**BOWERS ELEMENTARY SCHOOL
MANCHESTER, CONNECTICUT
STATE PROJECT NO. 077-0239 RNV
ADDENDUM NO. 7
March 2, 2022**

I. REVISIONS TO SPECIFICATIONS

6 EAST PARTIAL II
 1/8" = 1'-0"

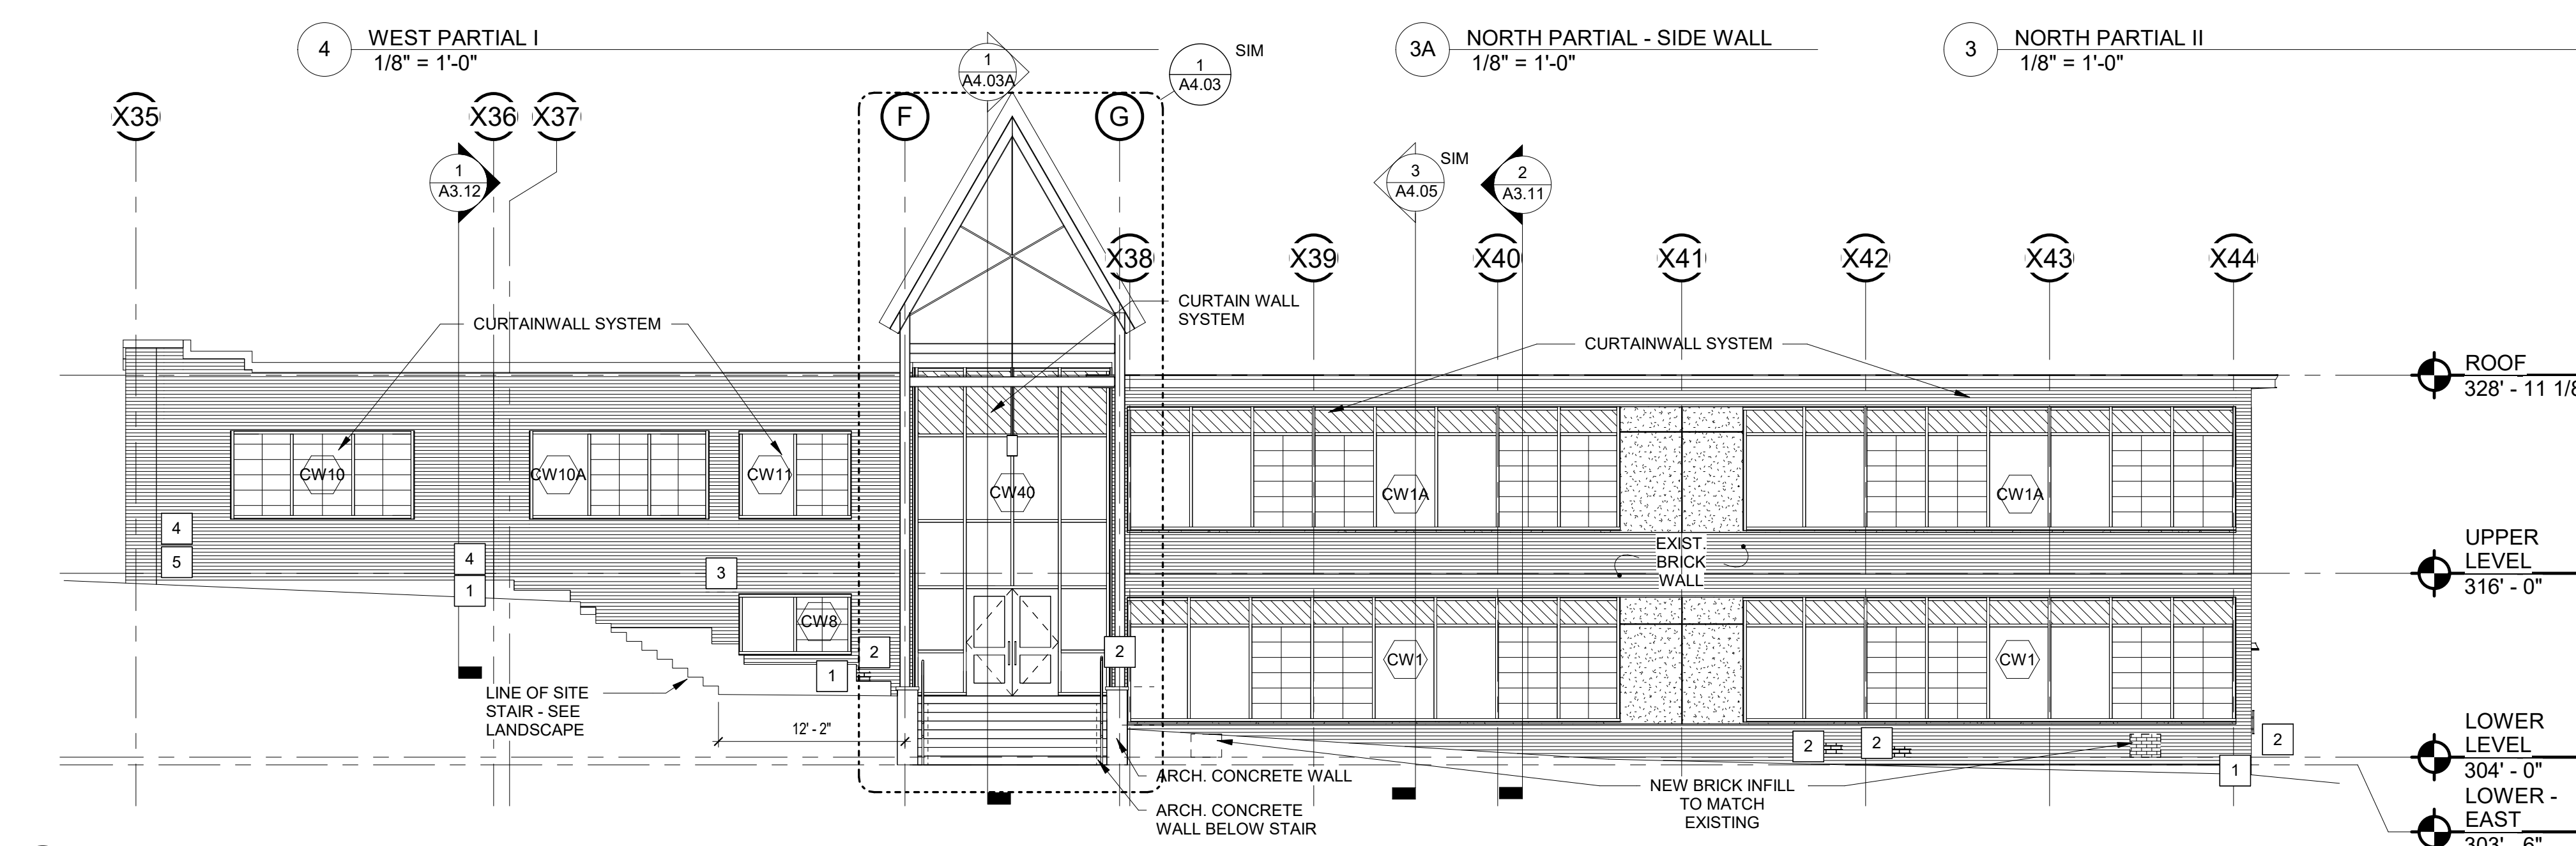
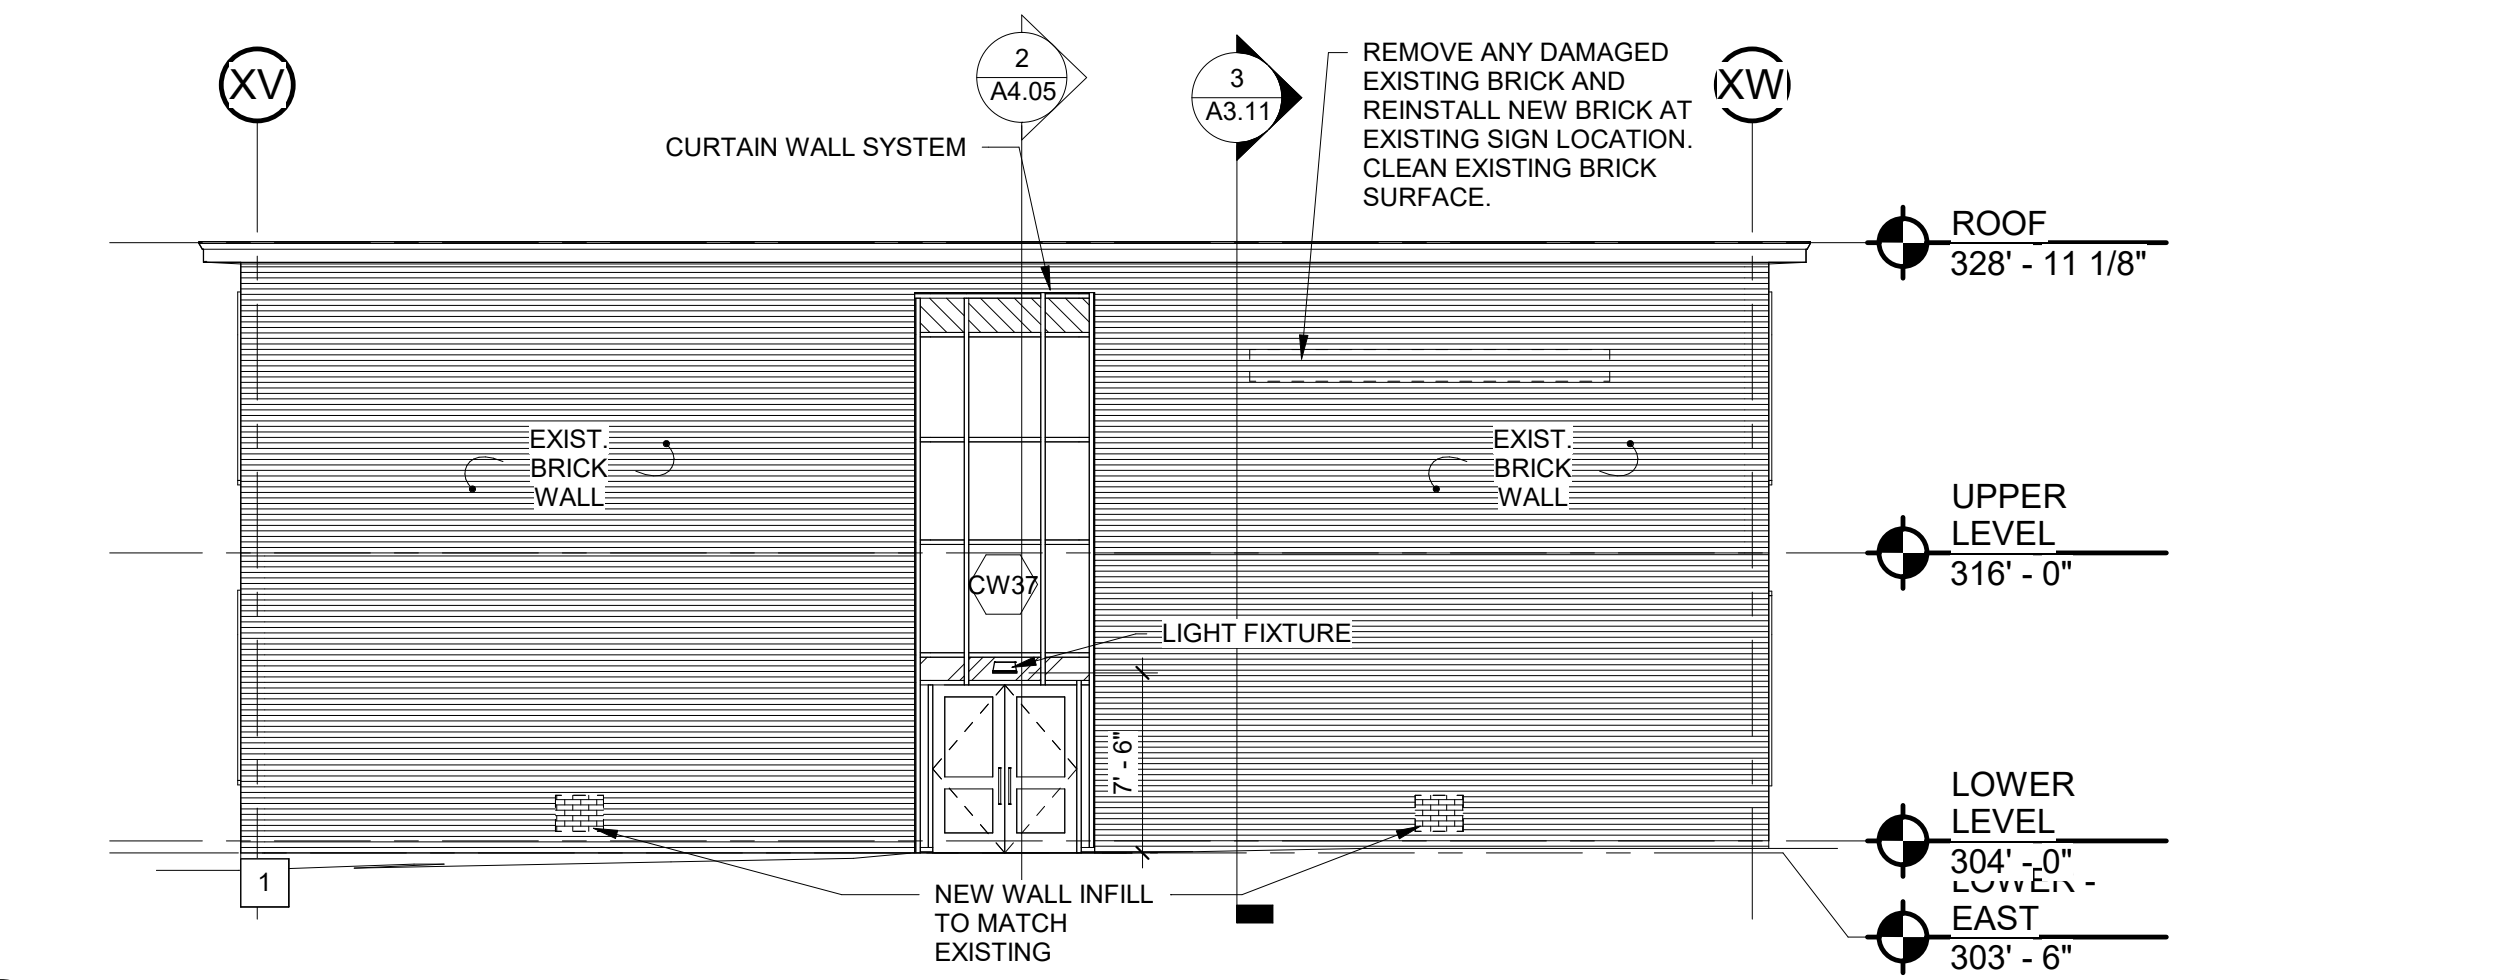
3. A1.01B:
 - Extend railing along north wall of east entrance stair as shown on sketch PB_SKA-09.
4. A3.02;
 - Replace sheet with attached A3.02.
5. A3.03
 - Elevation 8; Revise per PB_SKA-09.
6. A3.11
 - Section 2; Revise per PB_SKA-09.
